RESPONSE TO FEMA COMMENTS ON SMITH CANAL CLOSURE DEVICE CLOMR

Subject: Interior Drainage / Street Detention Storage

Project: Smith Canal Drainage Shed

FILE SPEC: P:\2091_SJAFCA_IDIQ\0060--Smith_Canal_Closure_Structure\05_Interior_Drainage\300_Design\SmithCanal--Topo.dwg
PLOT DATE: Jul 13, 2010 -- 3:56pm

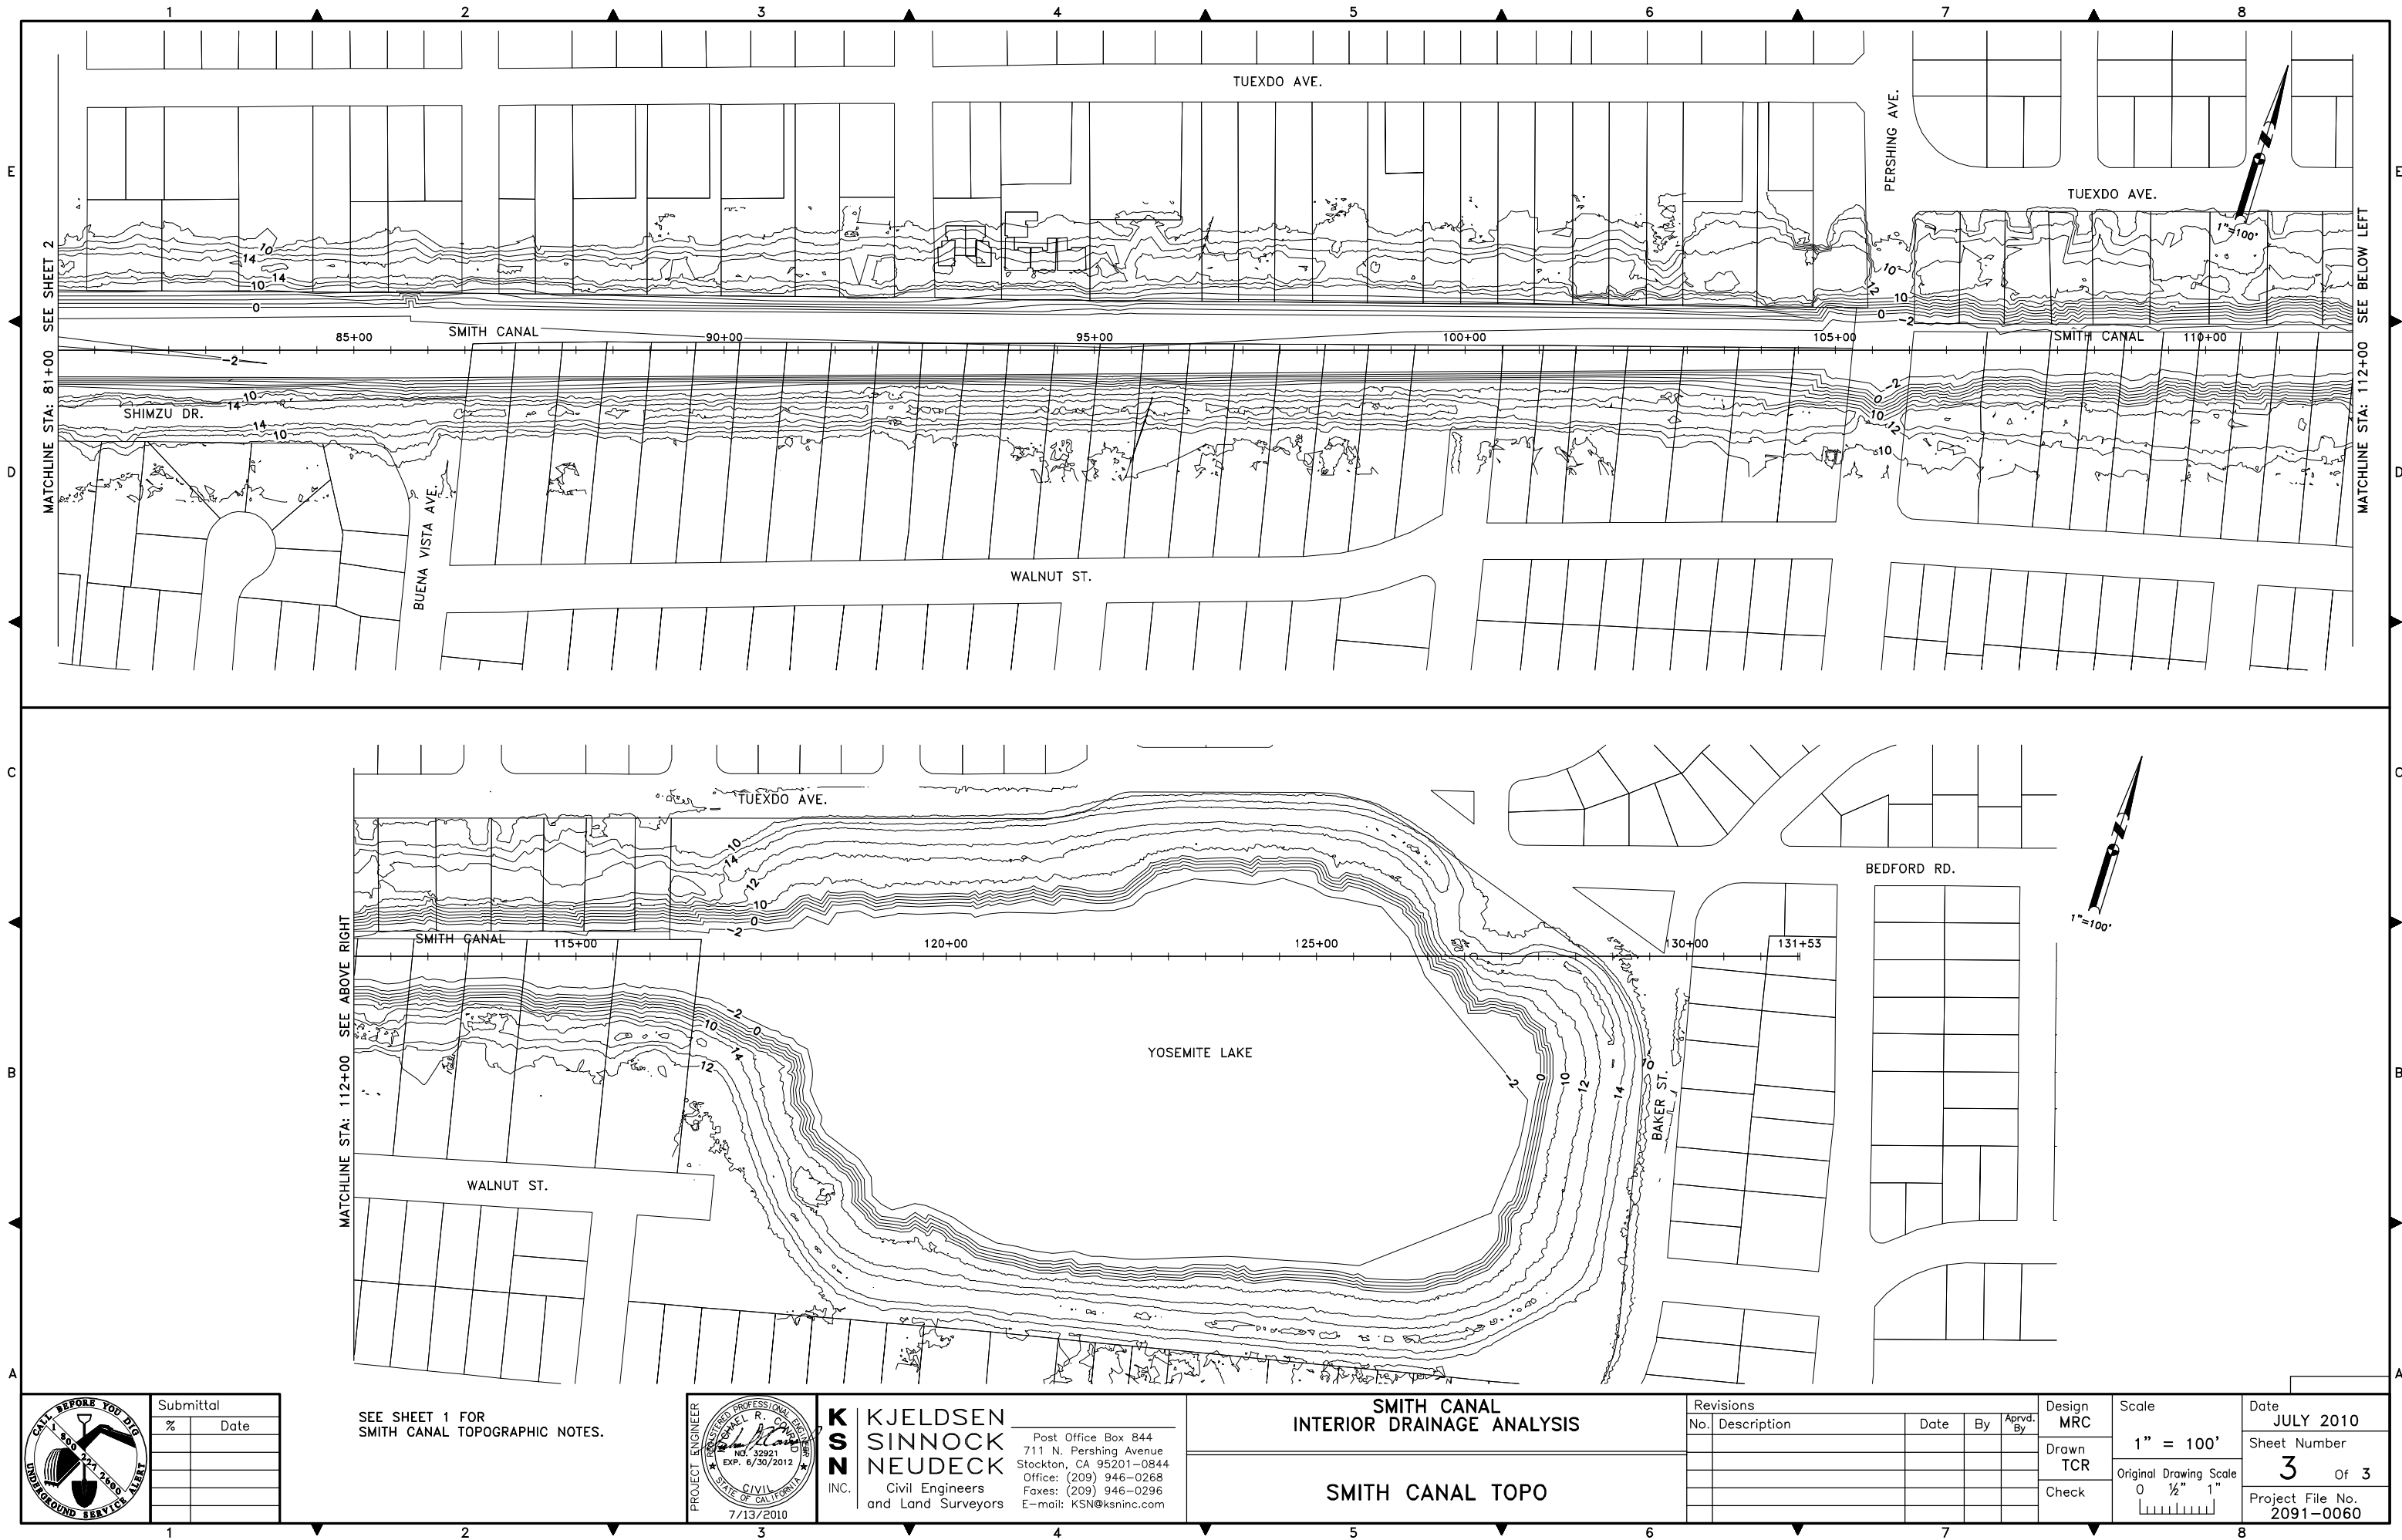
- 6) *Please provide the topographical data used for the Smith Canal storage calculation. The topo should be certified by a registered engineer.*

Response: A topographic map of Smith Canal is provided (Attachment 2).
